NO.	IDENTIFICATION NO.	DESCRIPTION	REF DESIG.	NOTE	ITEM
STOCK LIST					
SUPPLEMENTARY DRAWINGS					
SIGNIFICANCE OF SYMBOLS AND ITEM NUMBER SUFFIXES B-PARTIAL ASSEMBLIES OR OTHER ITEMS NOT SPECIFIED AS "B" D-DRAWINGS WITH STOCK LIST S-PARTS SHIPPED LOOSE W-WHERE ITEMS HAVE REFERENCE DESIGNATIONS, THEY MAY BE USED IN LIEU OF ITEM NUMBERS ON THE DELINEATION. ✓ IN "REQ" COLUMN OF STOCK LIST-QUANTITY AS REQUIRED ✓ IN "REQ" COLUMN OF SUPPLEMENTARY DWG LIST-DRAWING REQUIRED ⊗ DENOTES MANUFACTURE DISCONTINUED ⊕ DENOTES MANUFACTURE LIMITED AB-DENOTES APPARATUS BOOK DRAWINGS UNLESS OTHERWISE SPECIFIED, ALL DIMENSIONS ARE IN INCHES, NONLIMITED DIMENSIONS OTHER THAN SIZE OF RAW MATERIAL SHALL BE HELD AS FOLLOWS WHEN EXPRESSED: TO 3 DECIMAL PLACES ± TO 2 DECIMAL PLACES ± AS ANGLES ±					
1660 TEL SET A-580099 USED ON DWS 1660A1 & A2 TEL SET CONNECTING DIAGRAM SCALE ~ WESTERN ELECTRIC CO. INC. ENGINEER OF MANUFACTURE CDS 6S A-580099

A-580099

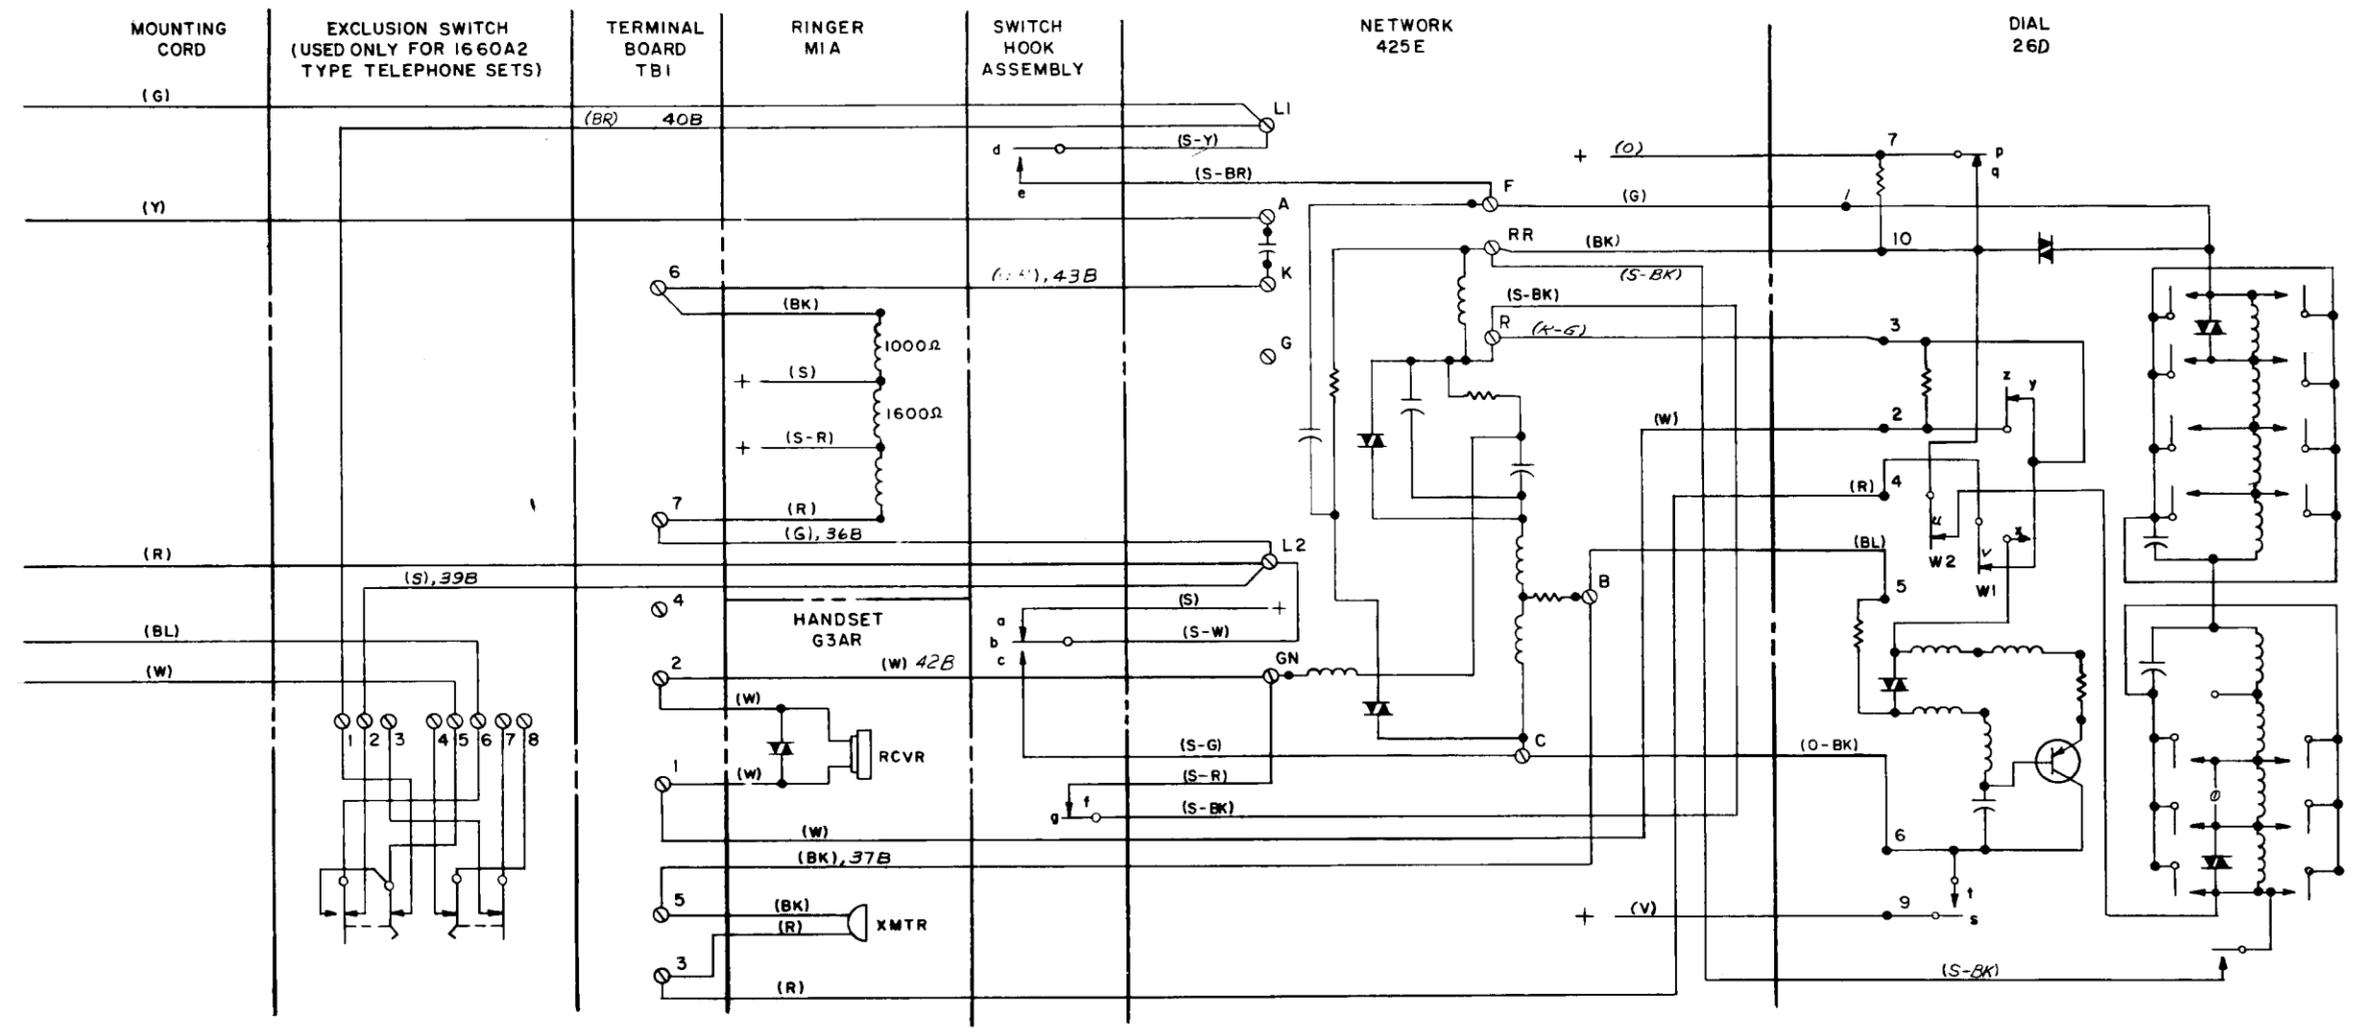
90	A-580099
89	
88	
87	
86	
85	
84	
83	
82	5-31-63 ISSUE-1
81	CHANGED: BK & R-6
80	DIAL LEADS WERE BK-BK
79	& R-R, RESP. P&Q DIAL
78	CONTACTS WERE OPEN,
77	VARIATOR IN LOWER
76	RT CORNER OF DIAL
75	PORTION WAS AT 0.
74	ADDED: RESISTOR
73	BETWEEN 7 & 0 IN DIAL
72	KSR 591822-B1-L
71	1-28-64 2
70	CHANGED: LEAD
69	40B (BR) WAS
68	40B (BR-BR).
67	AED 443548-B1-L
66	4-29-64 3
65	CHANGED: 26D
64	DIAL INFO WAS
63	26B DIAL INFO;
62	S-SK LEAD FROM
61	DIAL WAS DOWN
60	TO TERMINAL P
59	OF NETWORK
58	W2 443602-A1-C-6
57	6-3-64 4
56	CHANGED: (S), 39B WAS
55	(S), 39B
54	W2 363517-B1-F
53	7-29-64 5
52	
51	
50	
49	
48	
47	
46	
45	
44	
43	
42	
41	
40	
39	
38	
37	
36	
35	
34	
33	
32	
31	
30	
29	
28	
27	
26	
25	
24	
23	
22	
21	
20	
19	
18	
17	
16	
15	
14	
13	
12	
11	
10	
9	
8	
7	
6	
5	
4	
3	
2	
1
